June 15, 2017

**BOARD OF COUNTY COMMISSIONERS
ORANGE COUNTY, FLORIDA
ADDENDUM NO. 3 / IFB NO. Y17-763-PH**

**NORTHWEST WATER RECLAMATION FACILITY REUSE WATER STORAGE
IMPROVEMENTS**

FIGURE 1

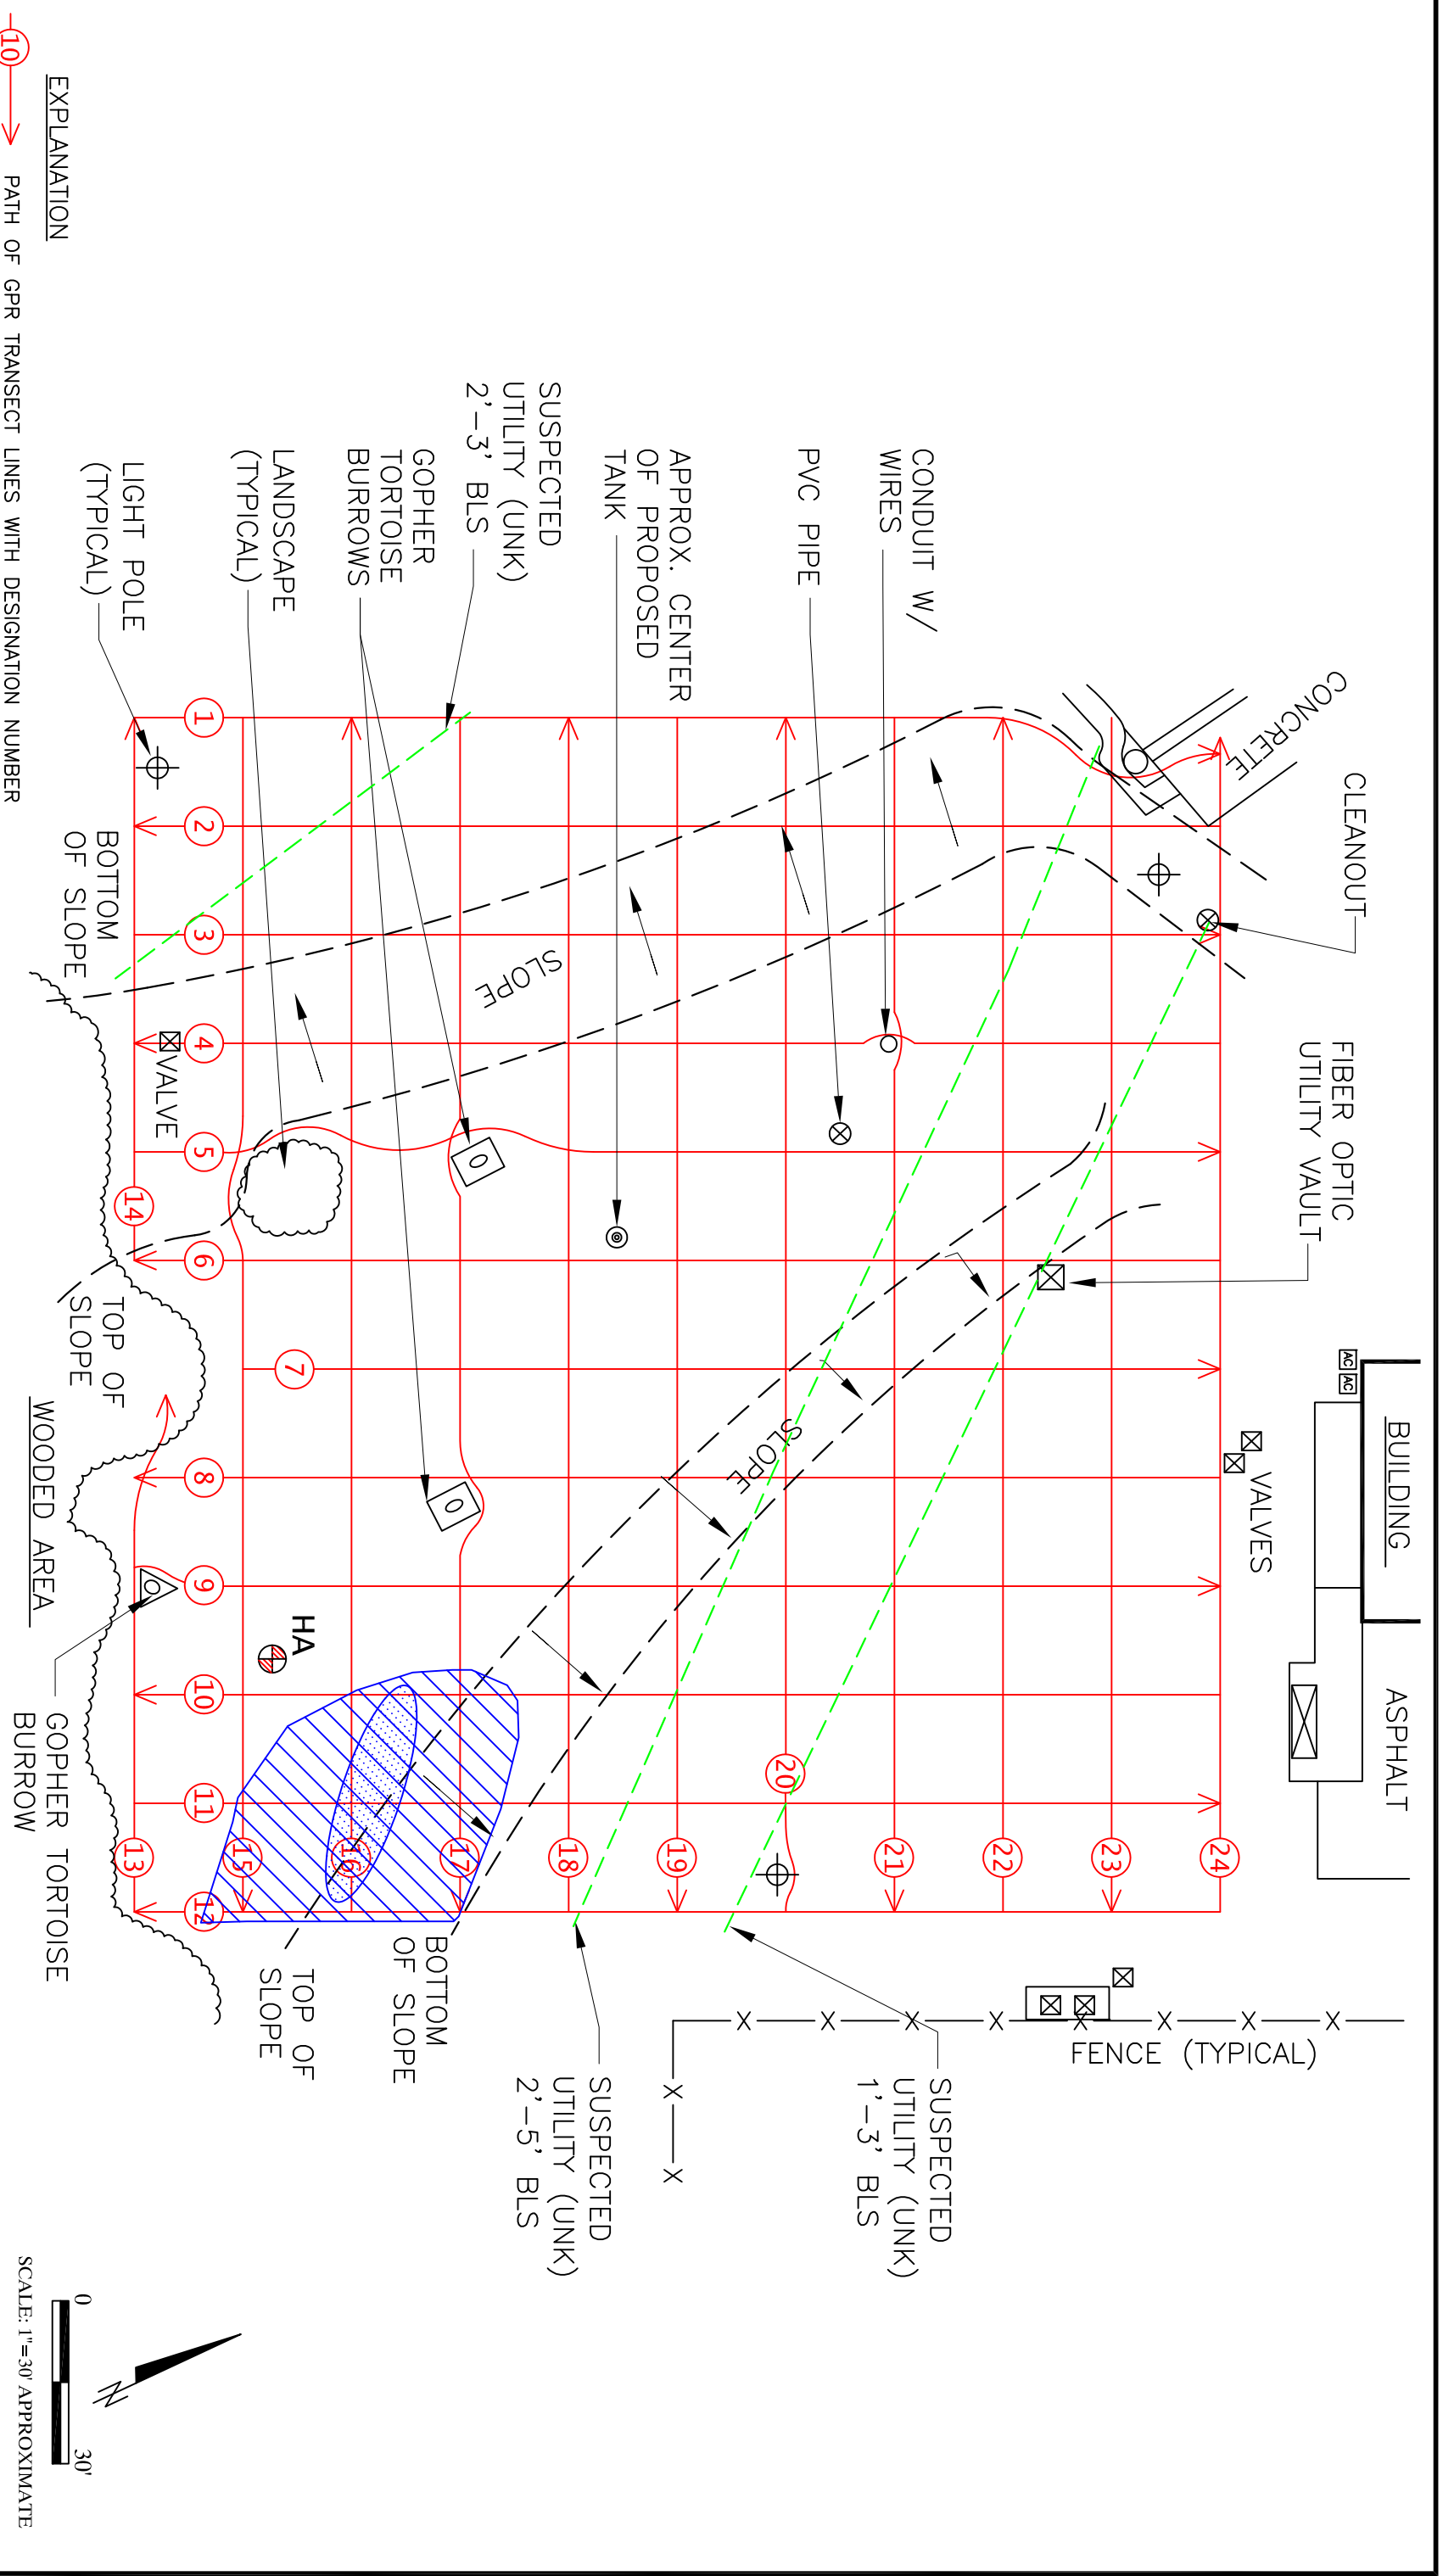
Question 48. In Appendix A – Geotechnical Reports – one report talks about a Ground Penetrating Radar (GRR) Survey was conducted in section 2. The GRR Report is mentioned again in section 6.3, but not until section 7.2, does it talk about excavation and backfill of 20 to 22 feet based on the GPR Report and the anomaly that was discovered. Can you please give us the limits of this anticipated excavation and backfill? Would this excavation be 20-22 feet deep from existing ground level or from the tank dirt grade of 110.67?

Question 55. Pertaining to our first question and Appendix A of the Geotechnical Report, Part 2.2 & 6.3 - Ground Penetrating radar (GPR), please provide the GPR Survey?

Subsequent to the issuance of the Geotechnical report, the ground storage tank was shifted further north such that the tank foundation will be approximately 10 feet outside the north corner of the GPR anomaly area at the closest point. The anomaly area is likely to be encountered by the Contractor along the outside half of the 20 feet wide tank construction work zone for a length of approximately 30 feet. The Contractor should compact this area in the work zone to a minimum of 95% of the modified proctor dry density value prior to installing pre-stressing wires (wrapping the tank). - This area should be monitored during construction. Compaction efforts that

The limits of the GPR anomaly are provided in revised Drawing Sheet C04. Also refer to the reply to Question No. 48. The GPR survey is provided with this addendum for informational purposes.

DRAWING NUMBER: C03

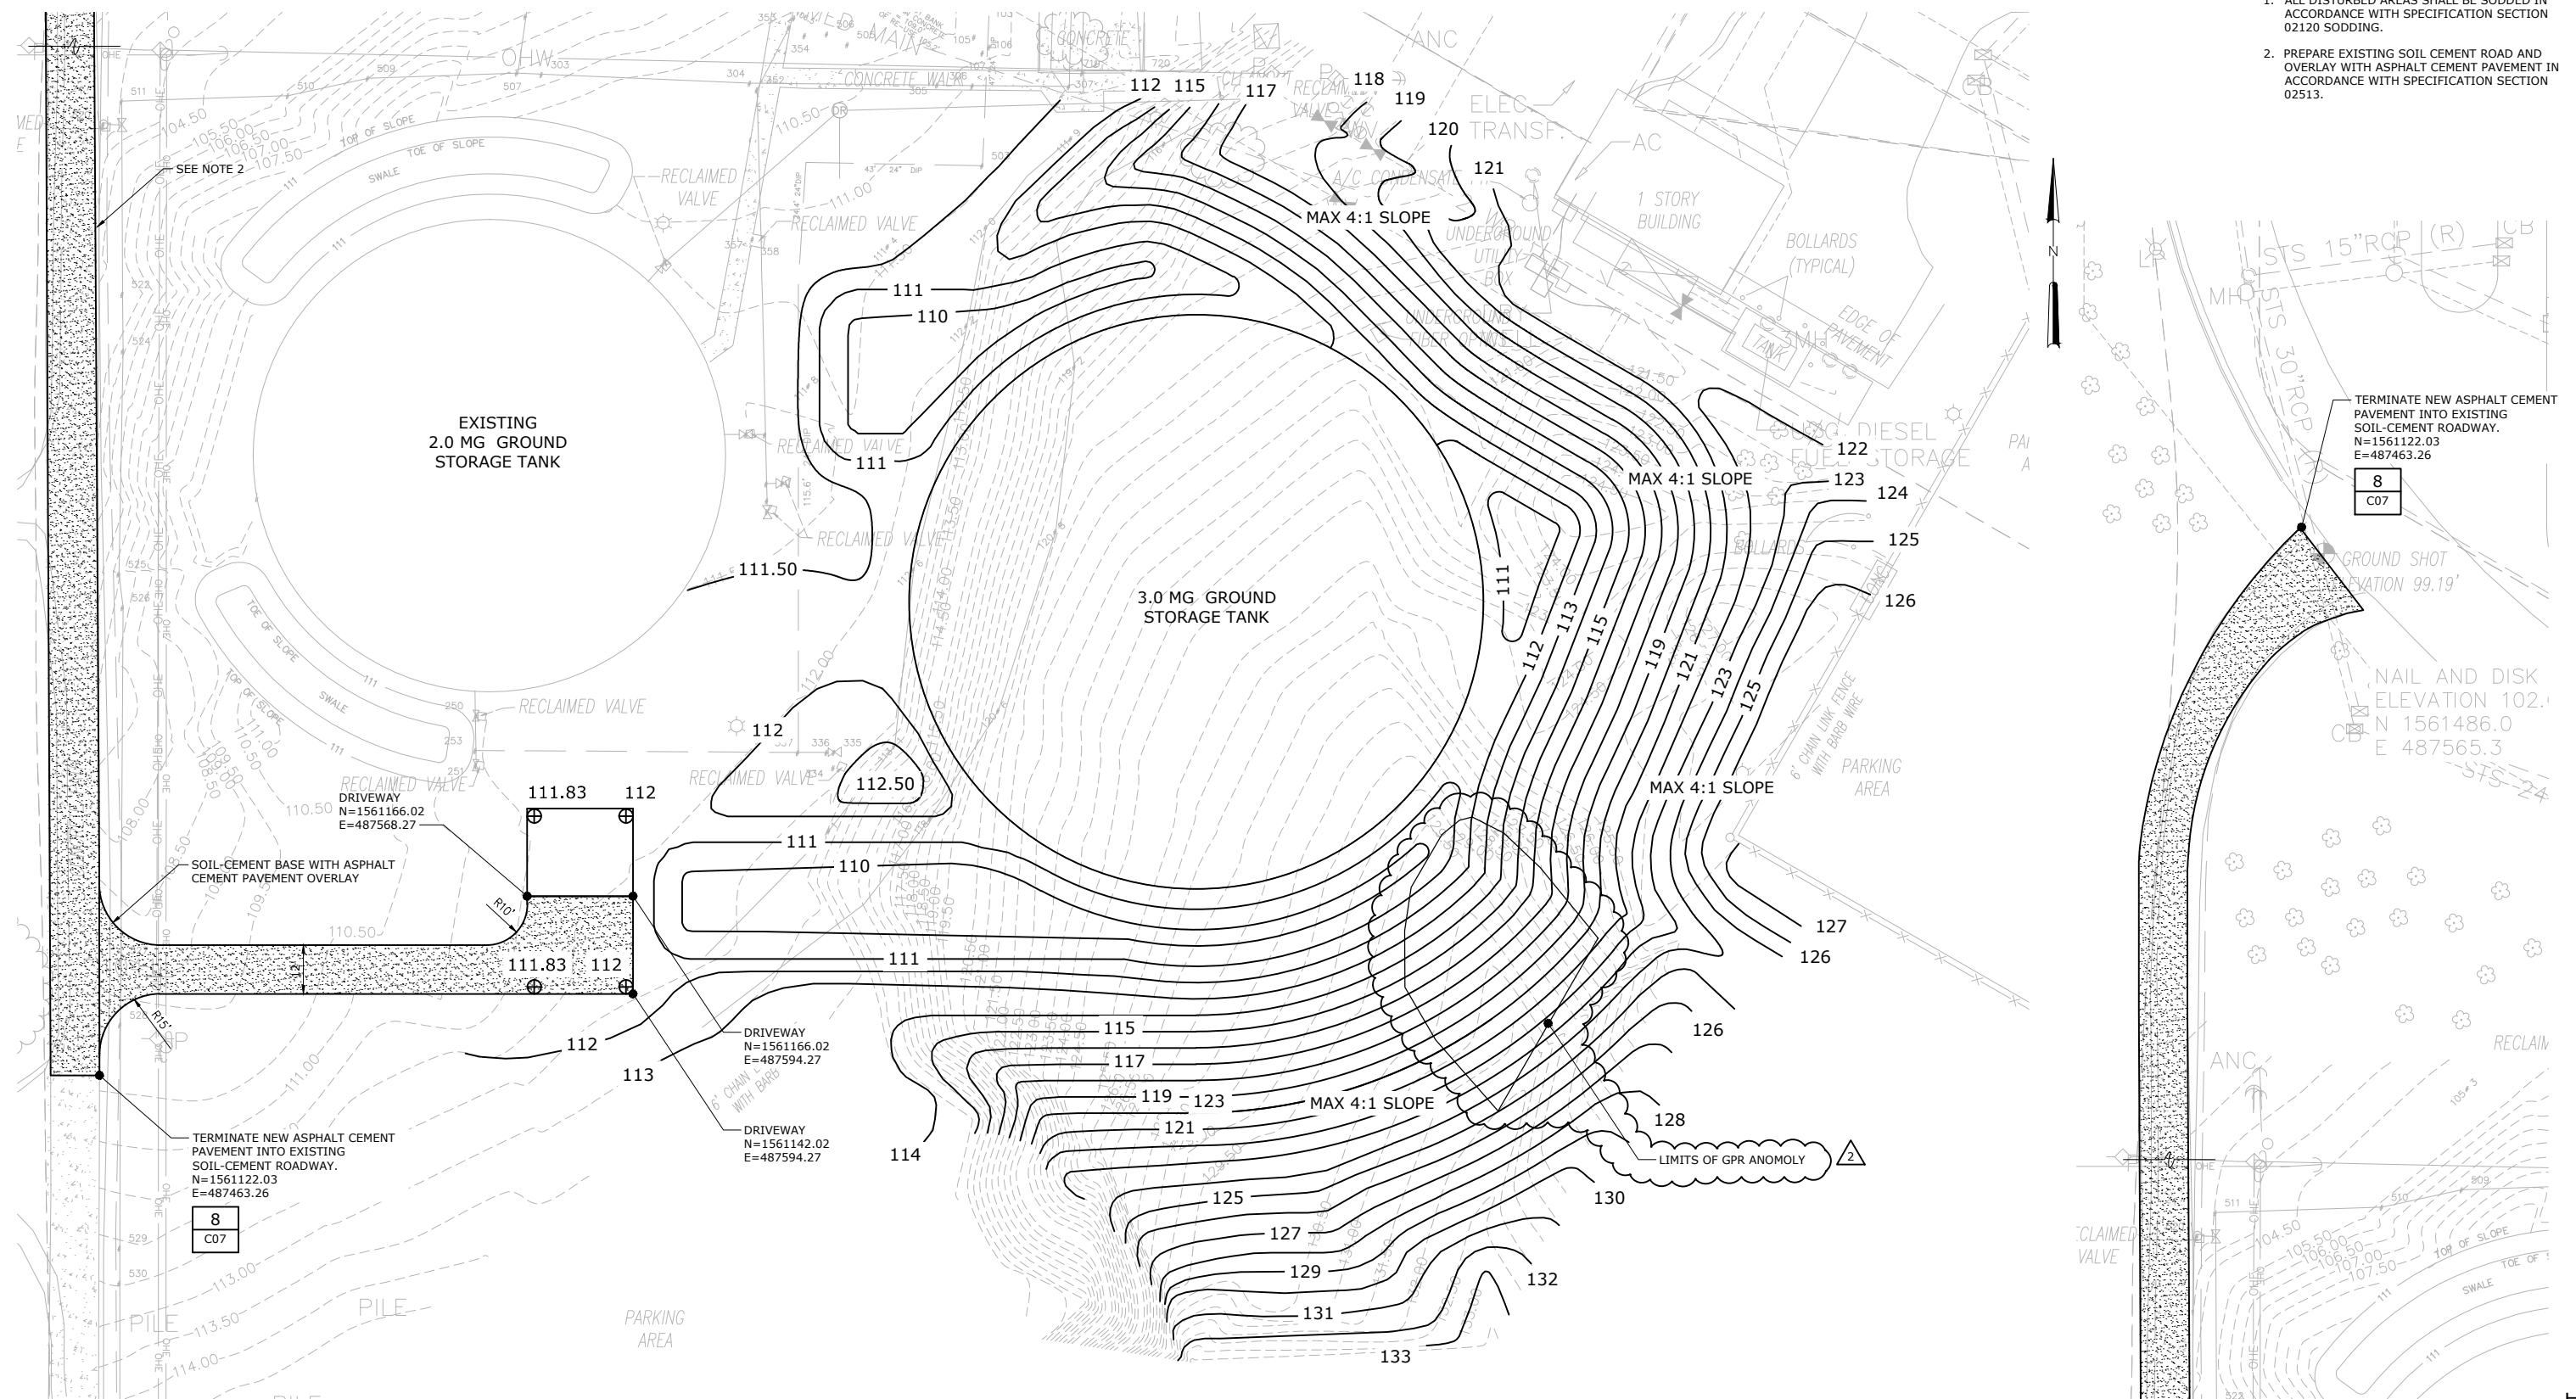
REPLACE Drawing C03 with revised Drawing C03. Pipeline tie-in connections are revised from harnessed flexible couplings to mega-couplings or MJ solid sleeves.

12 INCH INLET
SECTION B
NTS

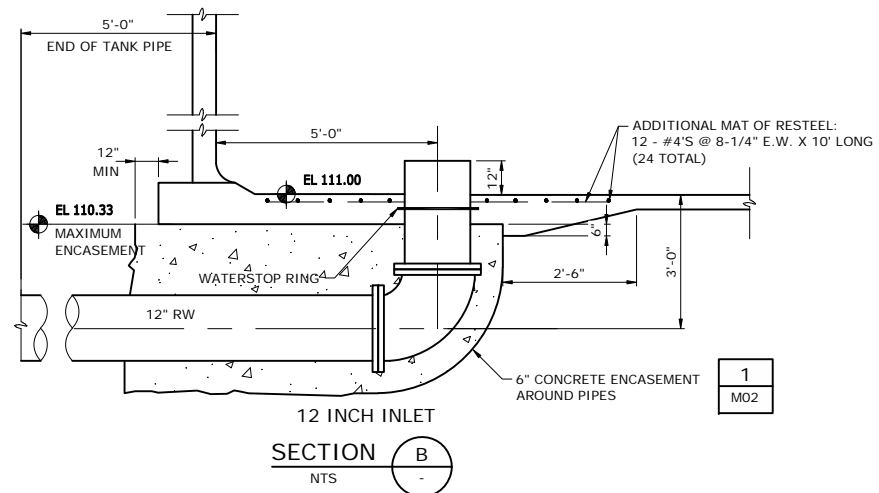
Question 20. Drawing Sheet M04, Note 2, requires the tank manufacturer to provide brackets for the 12" stand pipe. Per Detail B, Sheet M02, the 12" Inlet pipe extends above the floor 12". Please confirm the height or elevation of the 12” pipe.

Brackets are not required for the 12” inlet pipe. Sheet M02, Detail B is correct, the inlet pipe extends 12-inches above the floor. On Sheet M04, DELETE Note 2 in its entirety.

REUSE STORAGE TANK ENLARGED PLAN
3/32"=1'-0"

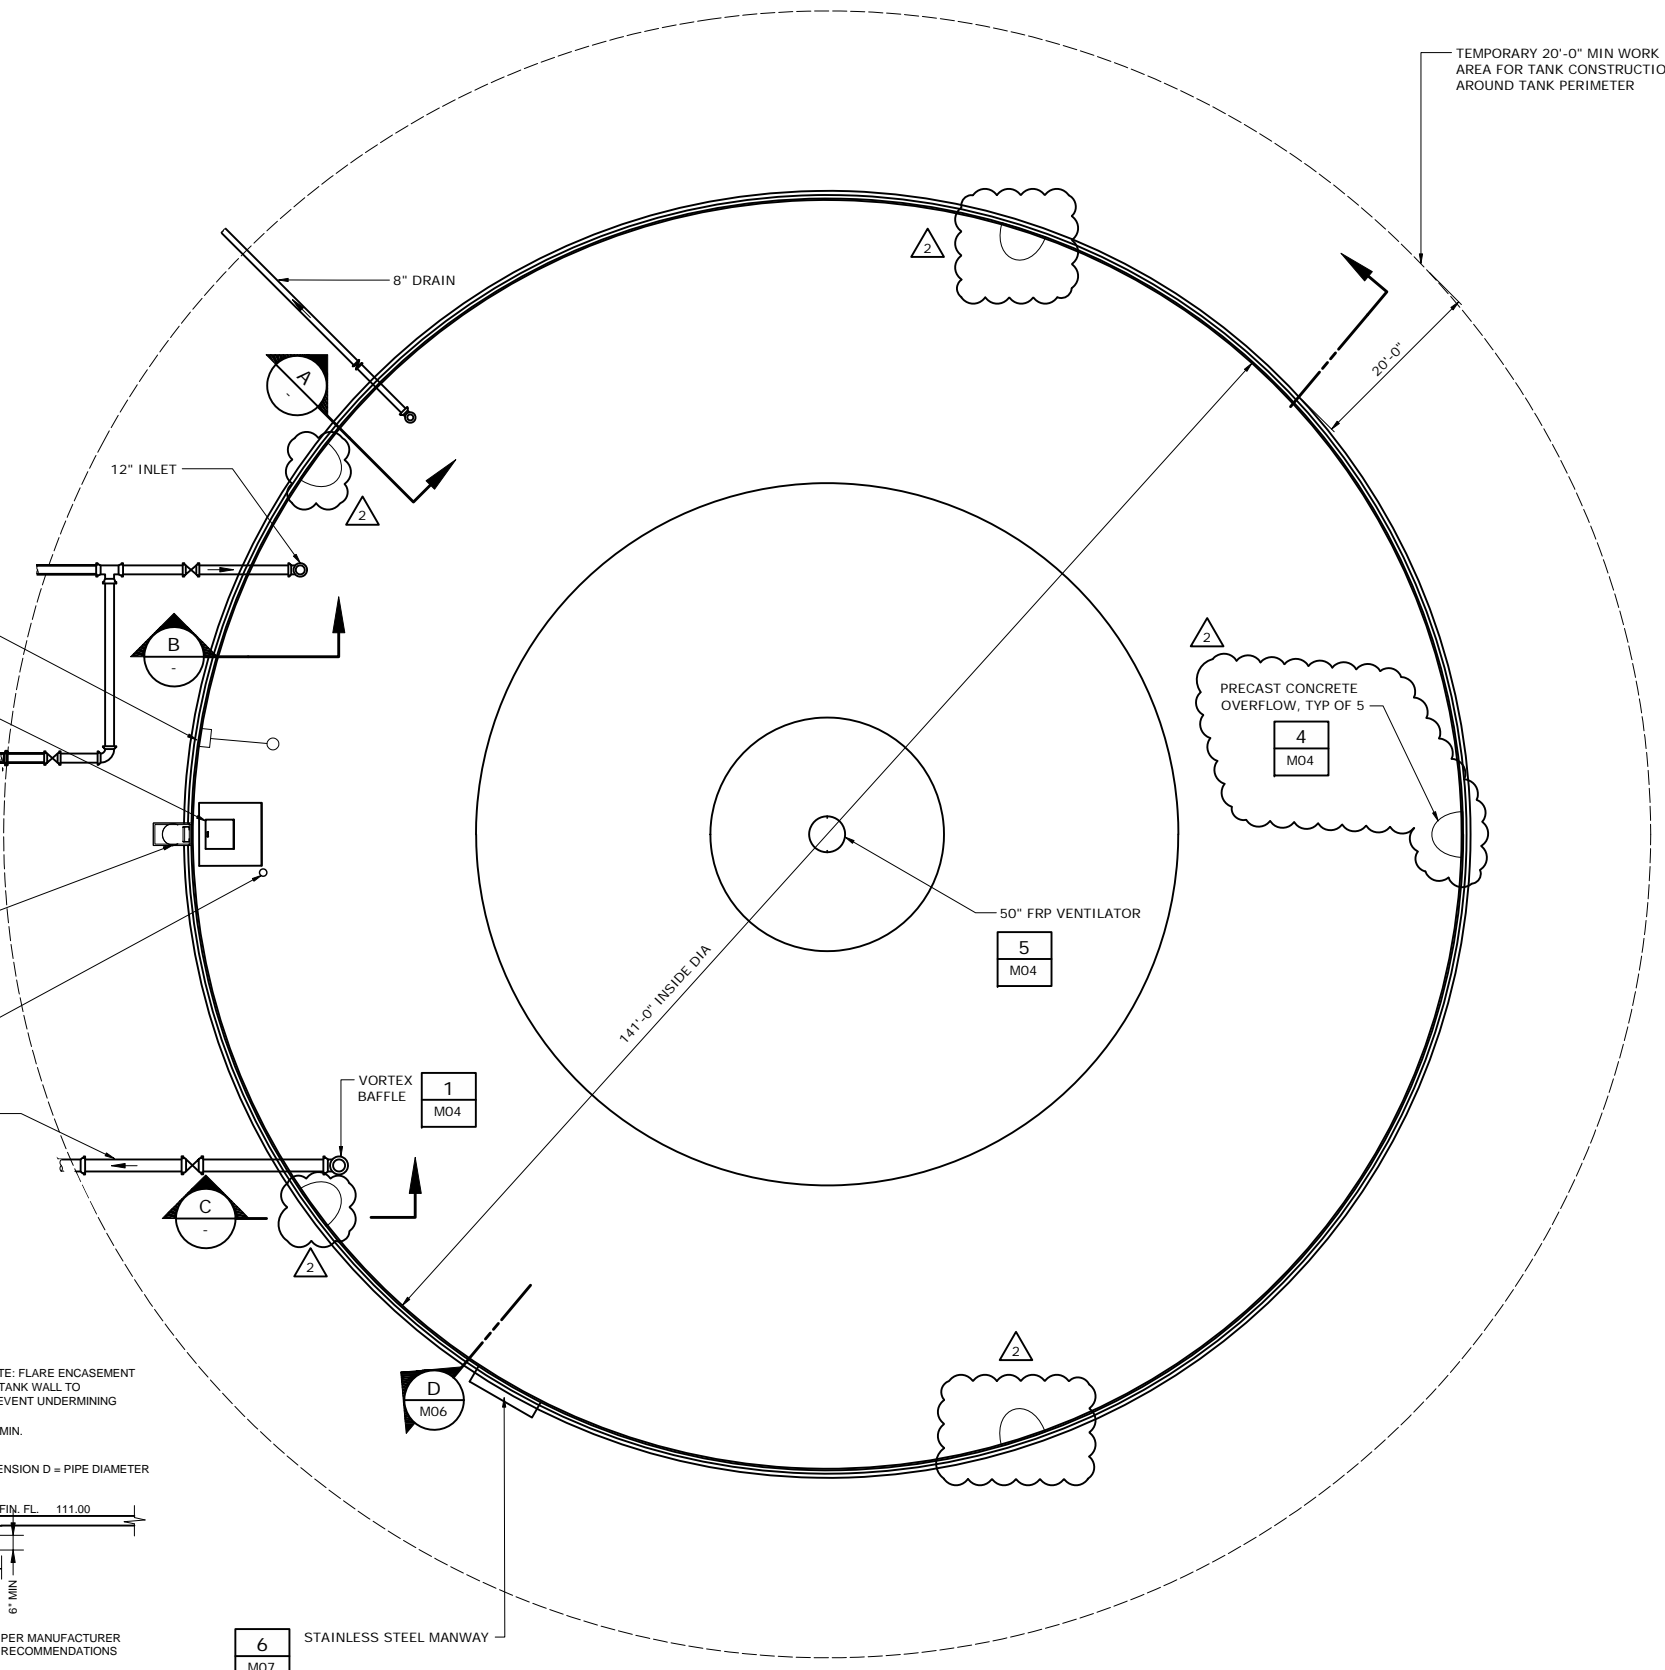
Question 11. Specification 13320-10, section 2.11 D, requires the tank dome overflows to be sized with an overflow area of at least three times the largest pipe. Drawing sheet M05 shows detailing of the parapet with callouts for the overflows to be #675 with a minimum of 6 required. Drawing sheet M02 shows 4 dome overflows. Please delete “4” and replace with “5”.

REPLACE Drawing M02 with revised Drawing M02. The number and locations of storage tank concrete overflows are revised.

Drawing M02 and M05 are revised to show typical of 5 dome overflows.
